Addendum #	1	Date Issued	4-19-2024
Project Name Job #	DSU Woods Hall Improvements - Phase 2		20233600
Bid Date Time	April 24, 2024		2 pm MDT

THIS ADDENDUM AMENDS AND BECOMES PART OF THE CONTRACT DOCUMENTS FOR EAPC PROJECT 20233600 DATED 1-16-2024. EACH BIDDER SHALL ACKNOWLEDGE RECEIPT OF THIS ADDENDUM BY MARKING THE ADDENDUM NUMBER AND DATE ON THE BID FORM.

FP1.0

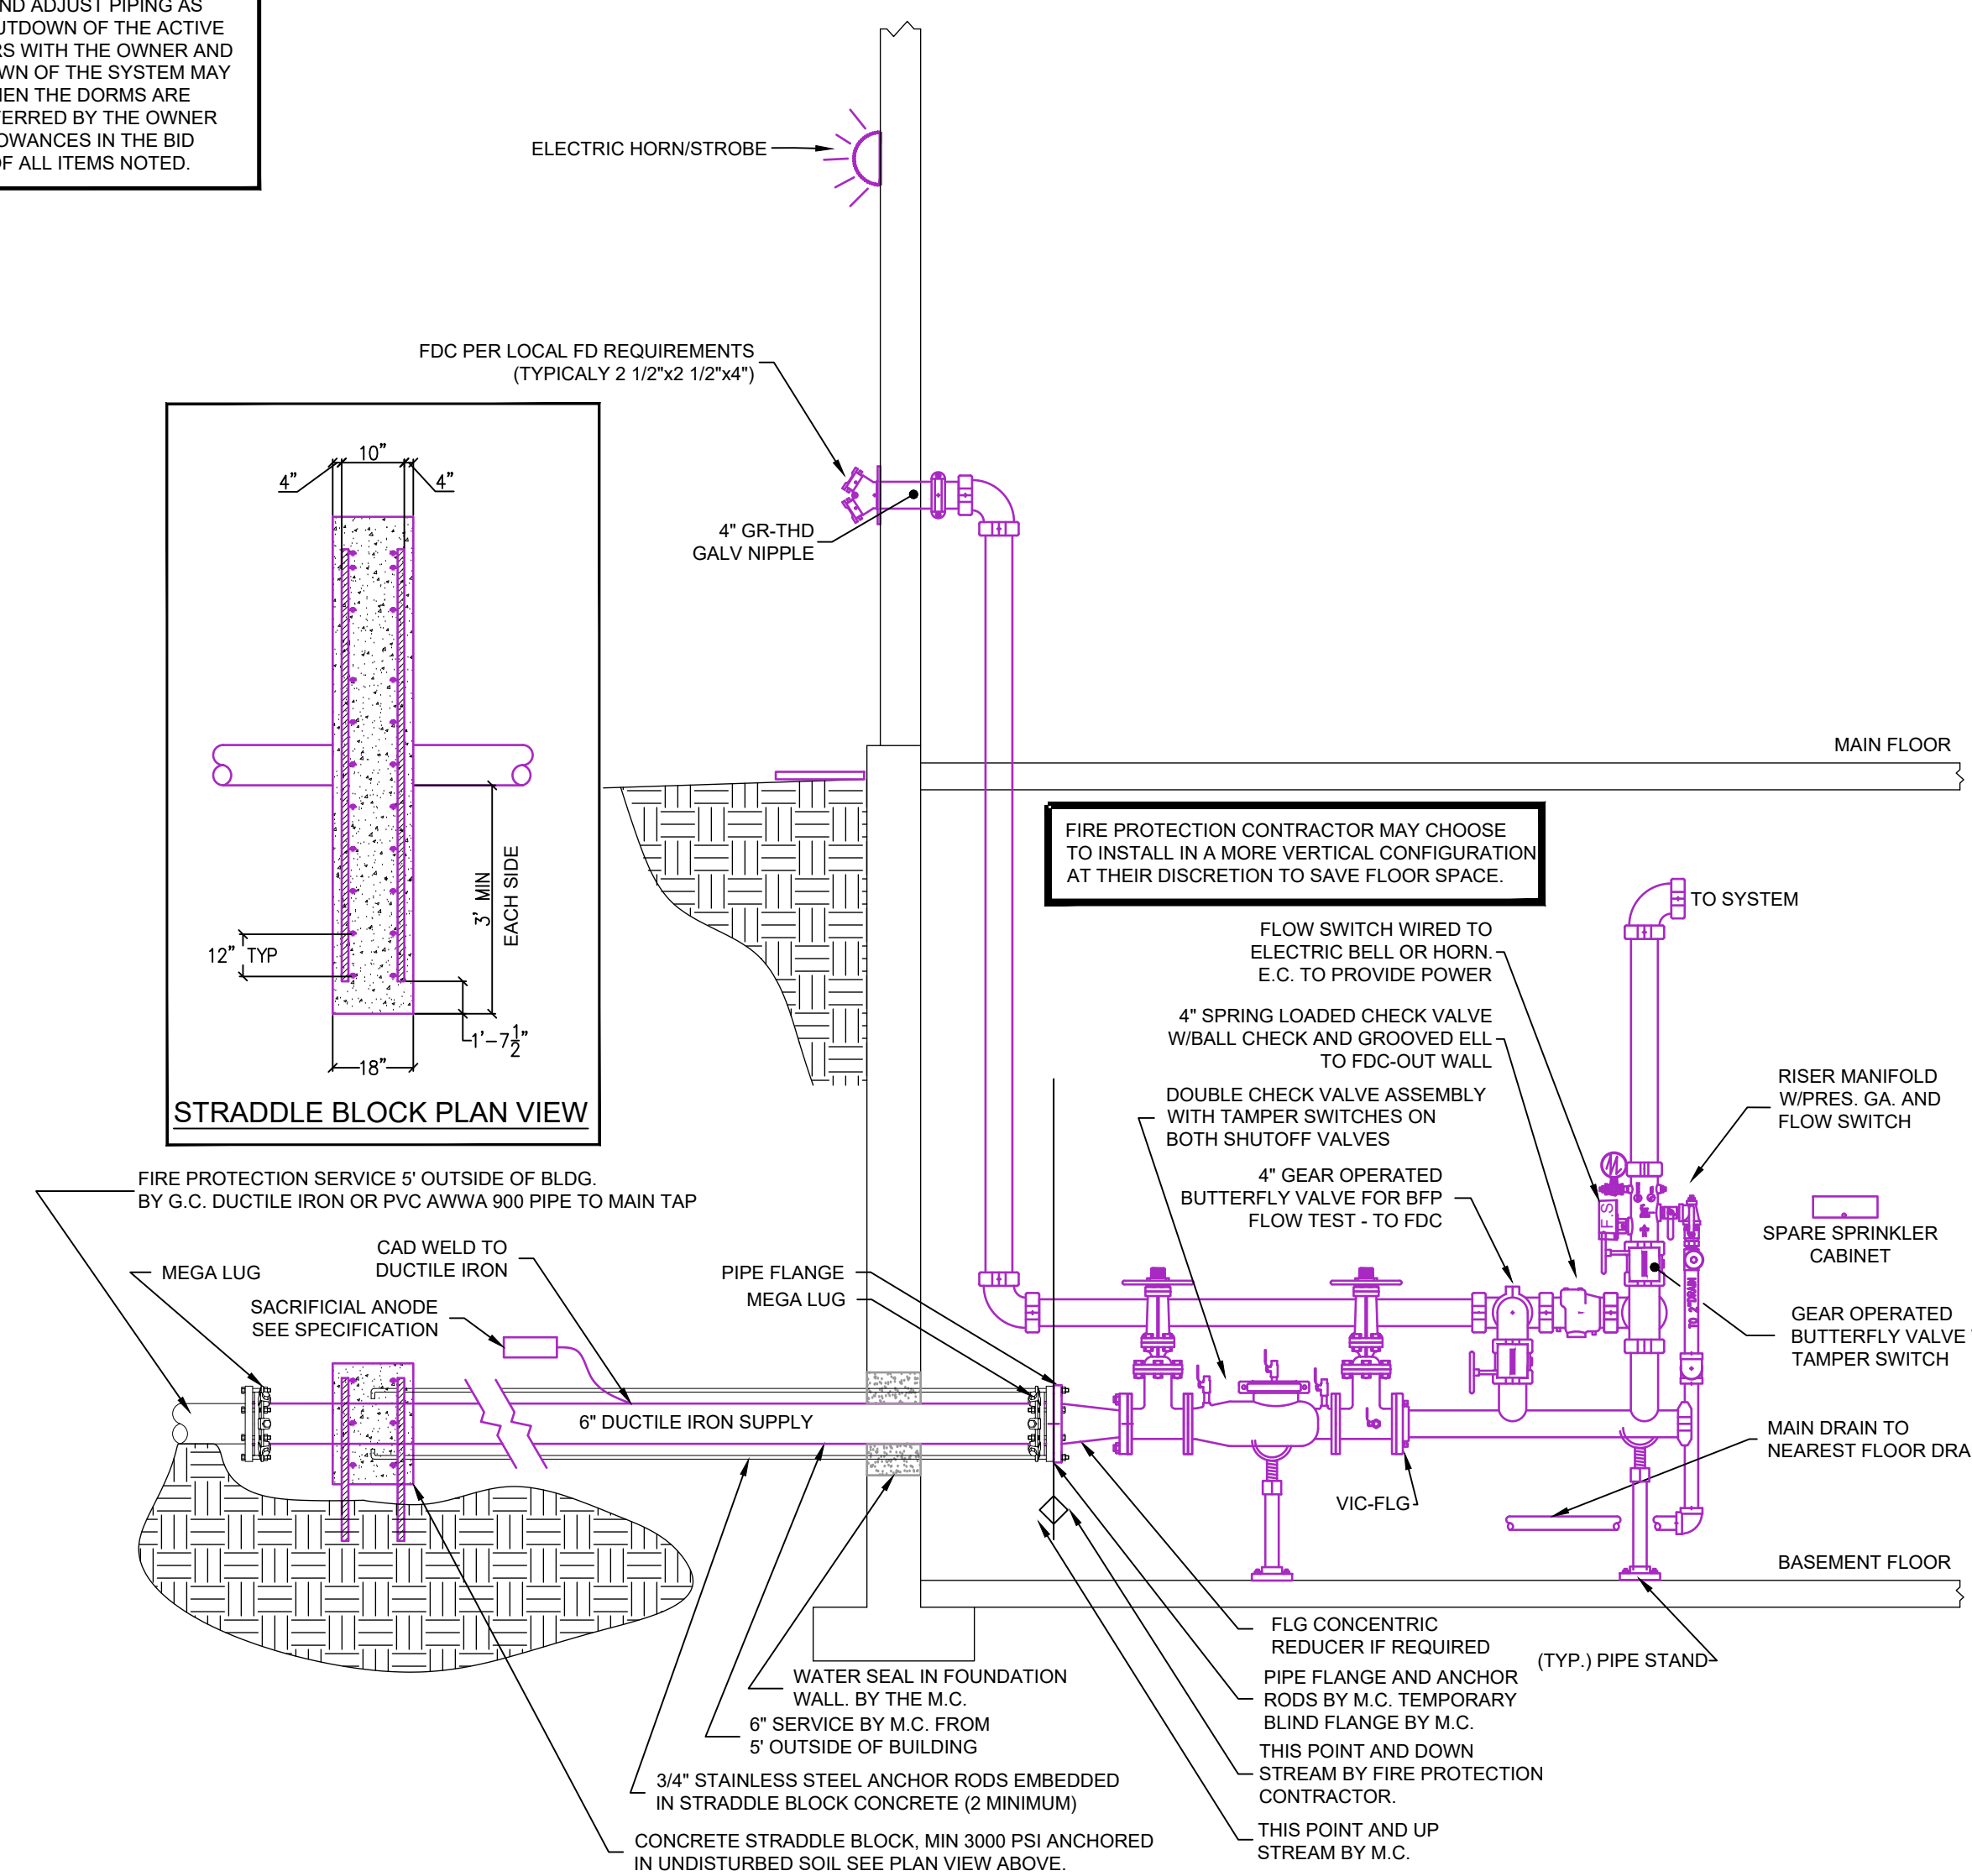
ITEM #10: SHEET FP1.0 - Basement Fire Protection Plan:

In Recreation Room 32 there are existing sprinkler piping and sprinkler piping mains with valves and associated drains that are hung below the existing structure. It is the intent that all efforts be put forth to raise any piping that can be while adhering to applicable codes and standards since this room will have an open to structure concept with no ceilings making all the fire sprinkler components accessible to the room occupants and potential tampering. The Fire Protection Contractor shall coordinate with the Architect/Engineers if any components cannot be raised.

- IN RECREATION ROOM 32 THERE ARE EXISTING SPRINKLER PIPING AND SPRINKLER PIPING MAINS WITH VALVES AND ASSOCIATED DRAINS THAT ARE HUNG BELOW THE EXISTING STRUCTURE. IT IS THE INTENT THAT ALL EFFORTS BE PUT FORTH TO RAISE ANY PIPING THAT CAN BE WHILE ADHERING TO APPLICABLE CODES AND STANDARDS SINCE THIS ROOM WILL HAVE AN OPEN TO STRUCTURE CONCEPT WITH NO CEILINGS MAKING ALL THE FIRE SPRINKLER COMPONENTS ACCESSIBLE TO THE ROOM OCCUPANTS AND POTENTIAL TAMPERING. THE FIRE PROTECTION CONTRACTOR SHALL COORDINATE WITH THE ARCHITECT/ENGINEERS IF ANY COMPONENTS CANNOT BE RAISED.

M1.1

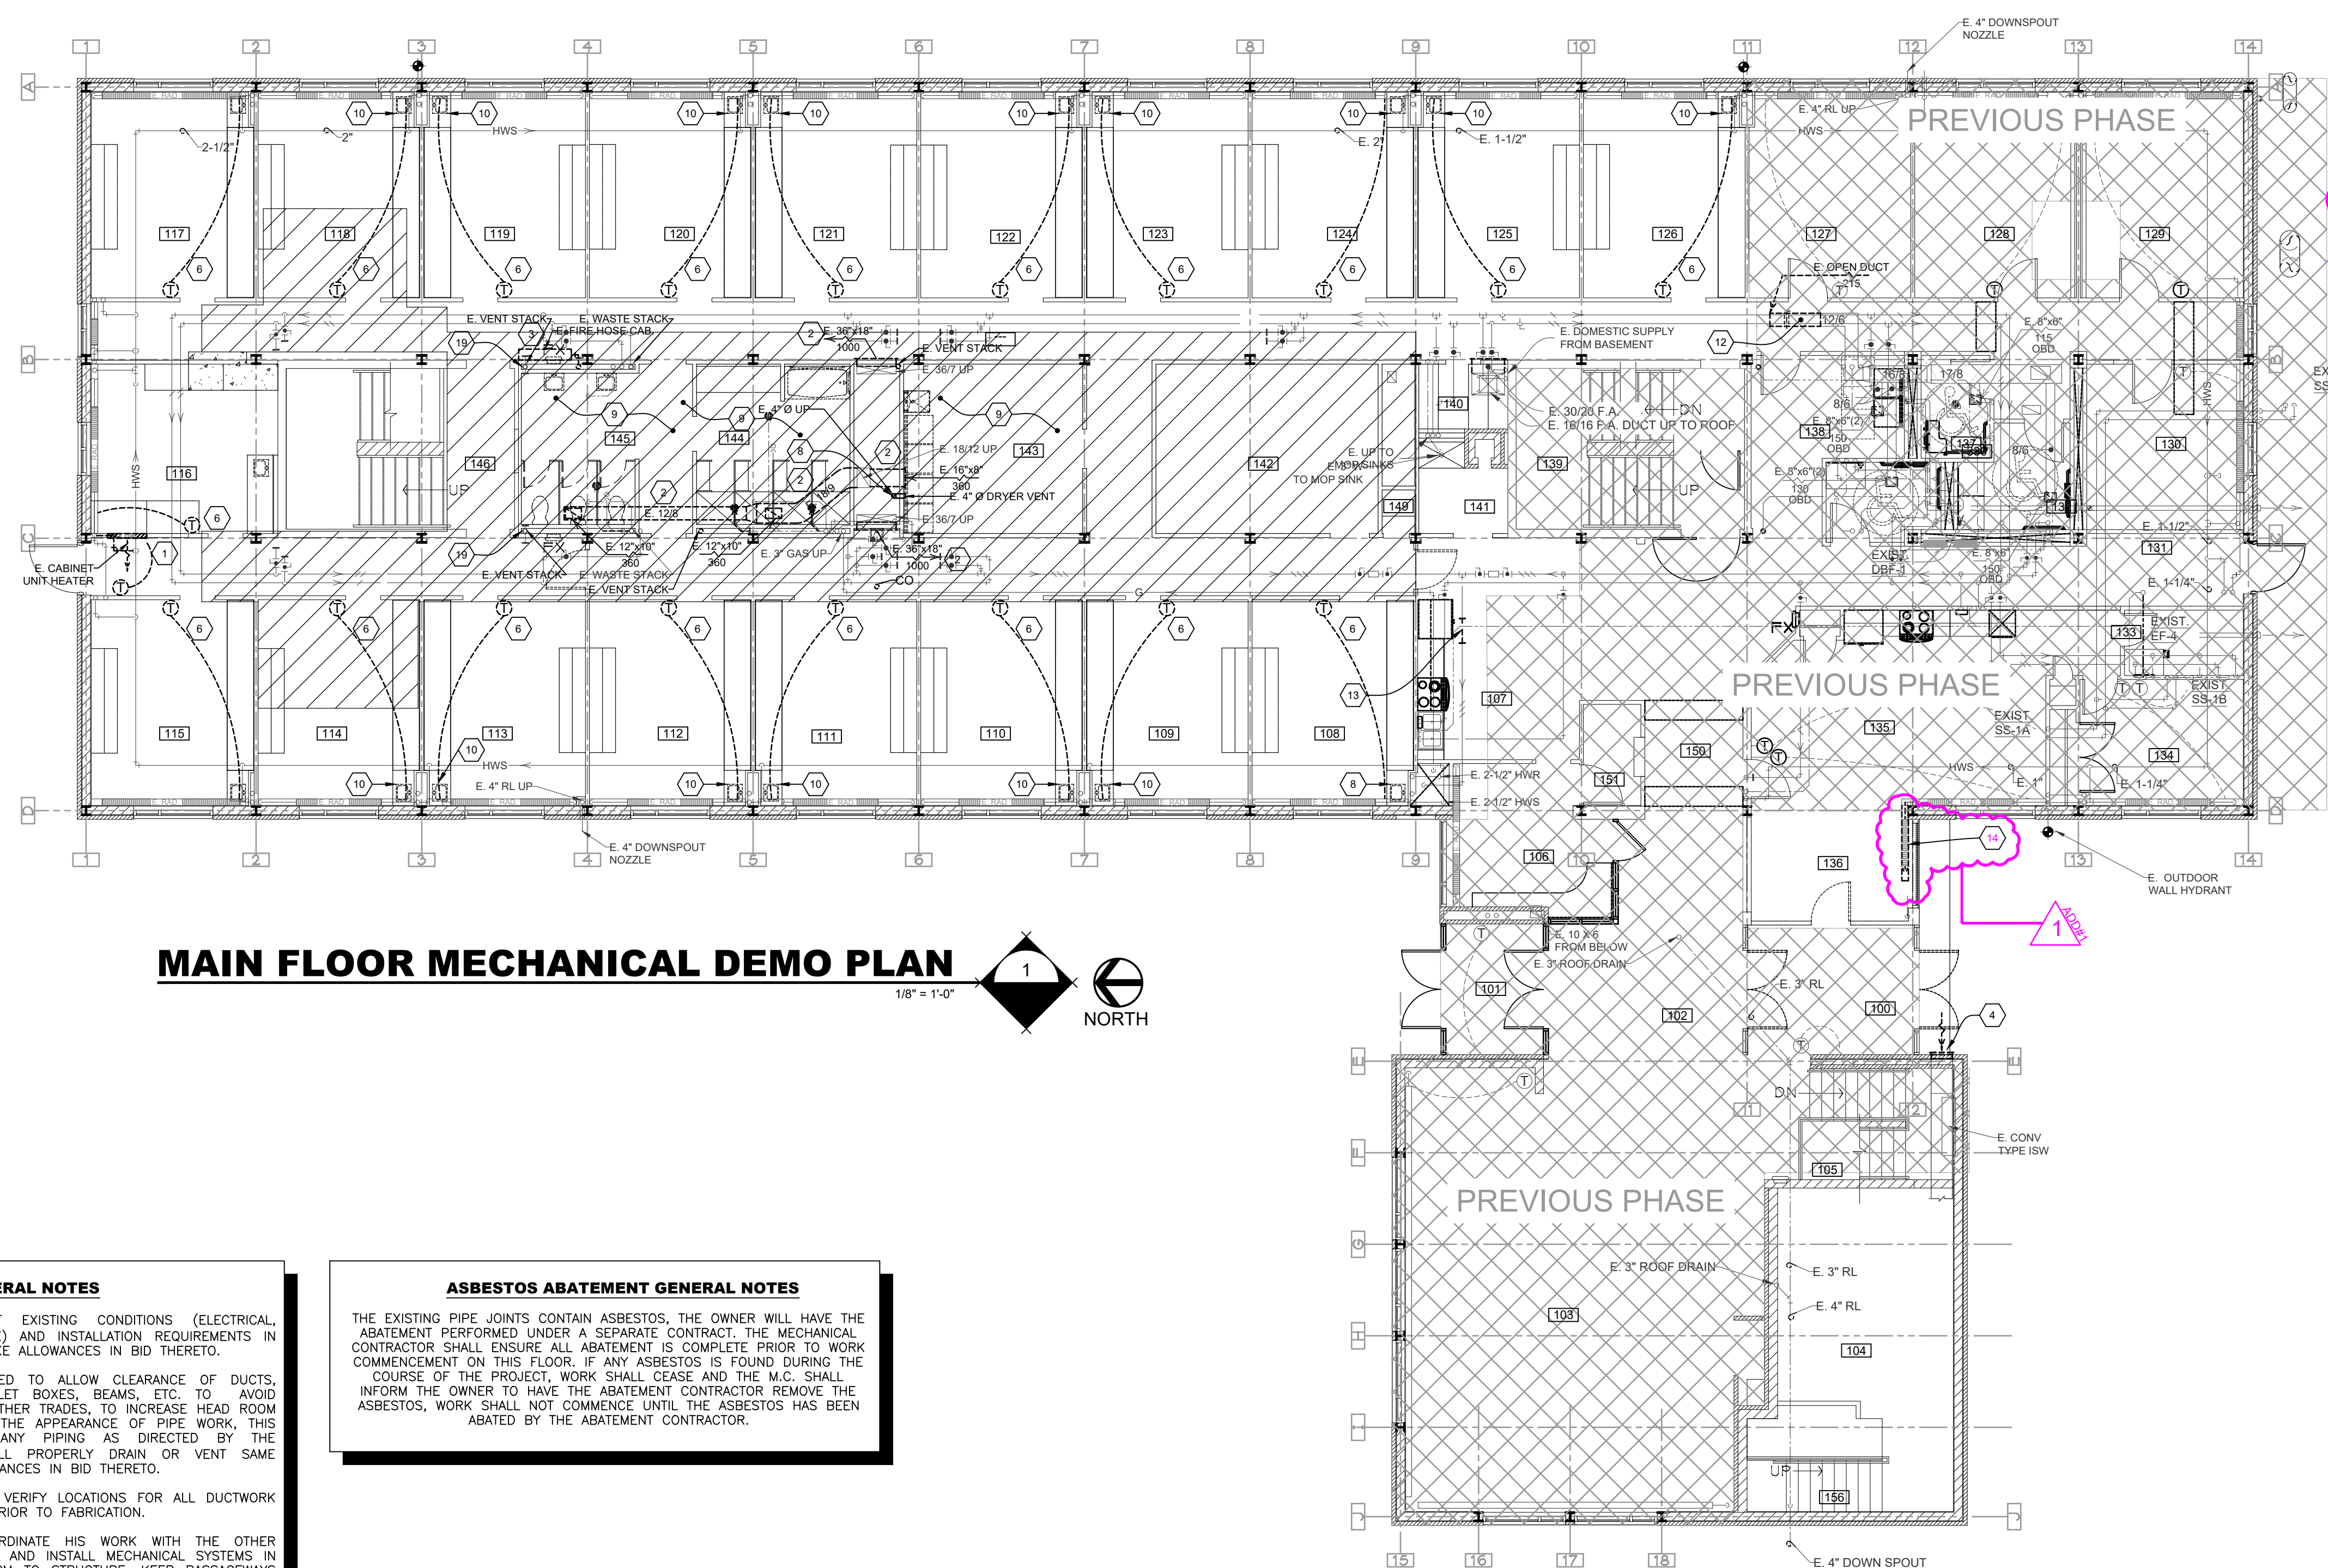
ITEM #11: SHEET M1.1 – Main Floor Mechanical Demolition

Added keynote for demolition of the existing radiation where the new elevator will be installed.

- REMOVE EXISTING HOT WATER RECIRC PIPING AS REQUIRED TO INSTALL A NEW CONNECTION.
 - UNDER PHASE II REMOVE THE EXISTING RADIATION AT THIS LOCATION FOR ADDITION OF THE ELEVATOR.

M1.3

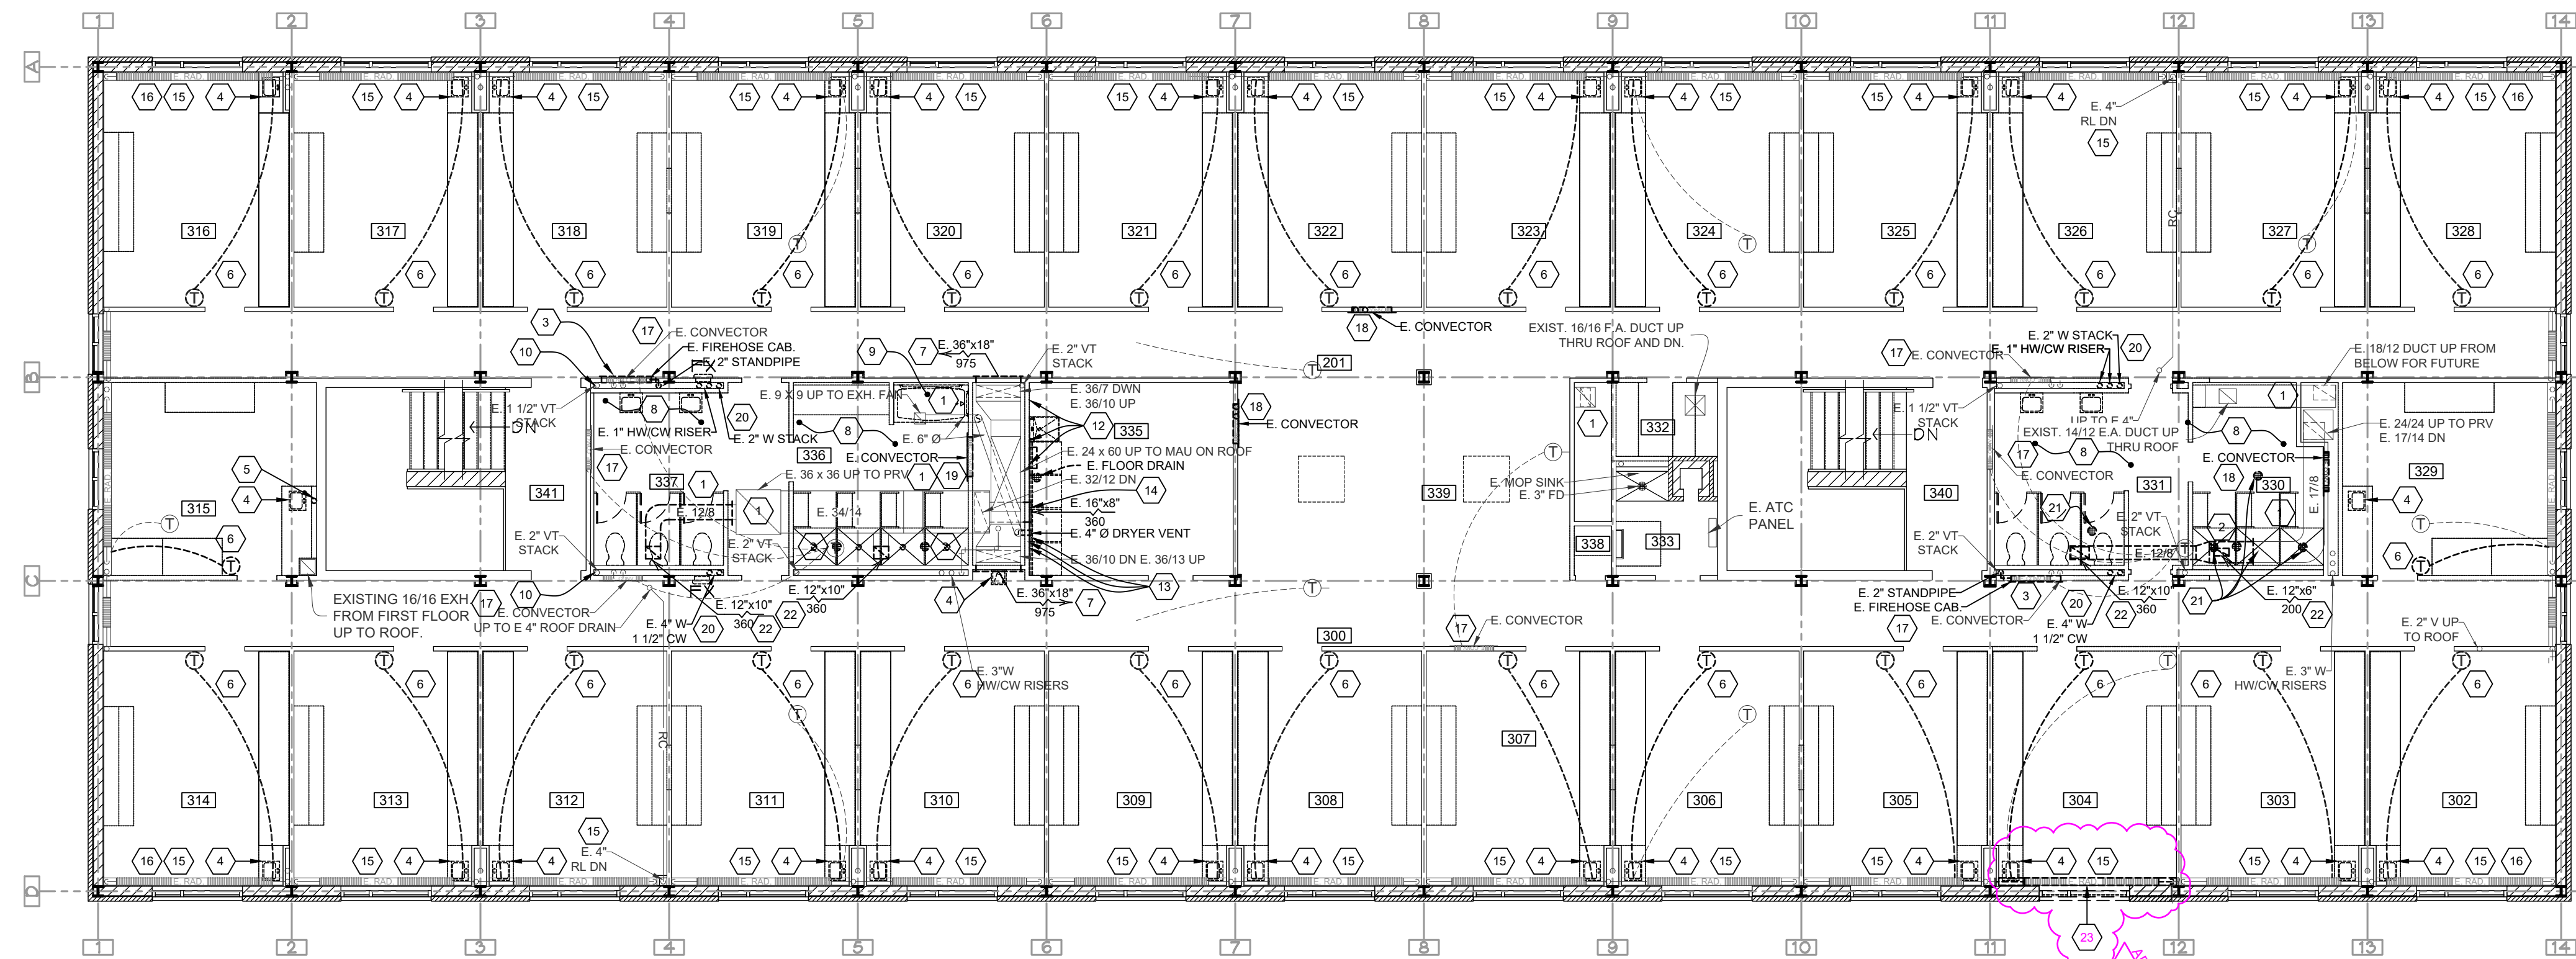
ITEM #12: SHEET M1.3 – Third Floor Mechanical Demolition

Added keynote for demolition of the existing radiation where the new elevator will be installed.

- UNDER PHASE II REMOVE THE EXISTING RADIATION AT THIS LOCATION FOR ADDITION OF THE ELEVATOR.
